# IDAP REPORT

<b>Property:</b>	33 Hillcrest Avenue Strathfield South Lot 20 DP 11678 DA2020/223 Demolition of existing structures and construction of a two (2) storey dwelling house with basement level, an in-ground swimming pool and associated external and landscaping works.
<b>Proposal:</b>	
<b>Applicant:</b>	Urban Link Pty Ltd
<b>Owner:</b>	T Zhu
<b>Date of lodgement:</b>	3 December 2020
<b>Notification period:</b>	17 December 2020 to 25 January 2021
<b>Submissions received:</b>	One (1)
<b>Assessment officer:</b>	D Strbac
<b>Estimated cost of works:</b>	\$782,735.80
<b>Zoning:</b>	R2-Low Density Residential - SLEP 2012
<b>Heritage:</b>	No
<b>Flood affected:</b>	No
<b>Is a Clause 4.6 Variation Proposed:</b>	Yes, FSR 0.7:1 (7.8%)
<b>RECOMMENDATION OF OFFICER:</b>	REFUSAL

Figure 8: Areas of basement included in GFA calculations highlighted in red.

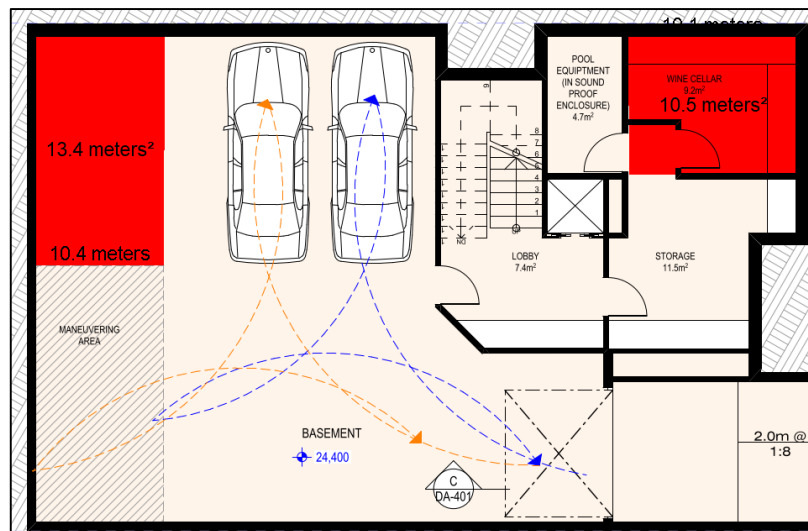
The proposed dwelling house exceeds the FSR allowance under Part 4.4 of the LEP. The Applicant's FSR calculations suggest the total GFA is 311m<sup>2</sup> with an FSR of 0.65:1. However, this calculation excludes the wine cellar room in the basement and the surplus area to the west of the two (2) basement car parking spaces (Figure 8).

Accordingly, these areas have been included in the FSR calculation undertaken as part of this assessment and contribute to an exceedance of the allowable GFA.

- 4.2.1 Floor Space Ratio – As discussed under the SLEP 2012 FSR assessment, the application has excluded the wine cellar room in the basement and the surplus area to the west of the two (2) basement car parking spaces. With the inclusion of these areas, the dwelling exceeds the maximum permissible FSR.

Figure 9: Proposed basement floor plan with ground floor building footprint outlined in red.

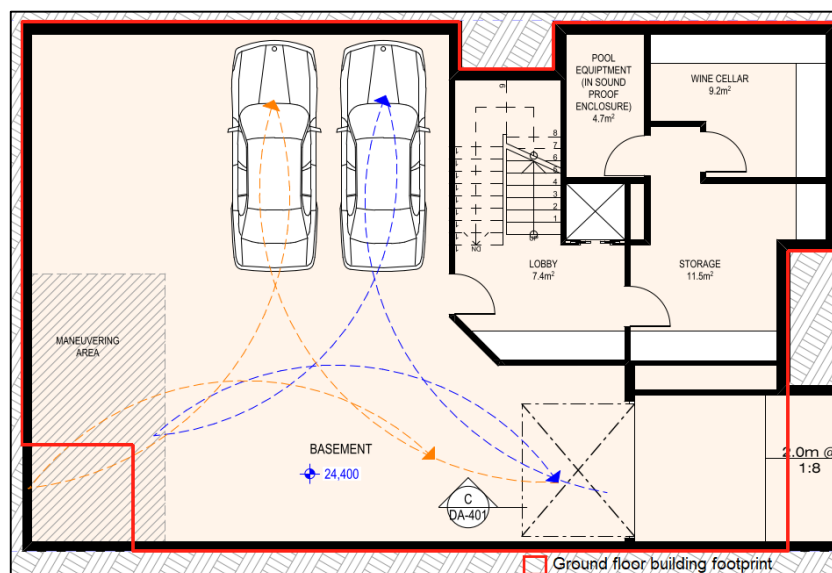
The proposal involves significant excavation works for the provision of a basement, driveway ramps and ancillary works. The proposed basement is mostly contained within the footprint of the ground floor level above. Whilst the revised basement design exceeds the footprint of the ground floor above (Figure 9), it is noted that the areas of the basement that exceed the ground floor footprint are required for sufficient manoeuvring area to allow vehicles to enter and exit the basement in a forward direction. The depth of excavation has been kept to minimum requirements to comply with Council's DCP controls. The proposed works are unlikely to disrupt or effect existing drainage patterns or soil stability in the locality or effect the future use or development of the land. It is unlikely to effect the existing and likely amenity of adjoining properties and there is no potential for adverse impacts on any waterways, drinking water catchment or environmentally sensitive areas. The excavation works proposed for the basement are considered to be reasonable and the non-compliance is minor and acceptable in this instance.

The proposed basement exceeds the footprint of the ground floor above. However, the area of the basement that exceeds the ground floor footprint is considered necessary to allow sufficient manoeuvring area for vehicles to enter and exit the basement in a forward direction. The area that extends beyond the ground floor footprint is minor and will not be highly visible nor contribute to excess bulk and scale. Further, the basement is appropriately setback and balanced by the proposed landscaping treatments within the setback zones. The proposed works are unlikely to effect the existing and likely amenity of adjoining properties. The basement has been kept to less than 1m above natural ground level and maintains an internal height of 2.2m. The excavation works proposed for the basement are considered to be reasonable and the non-compliance is minor and acceptable in this instance.
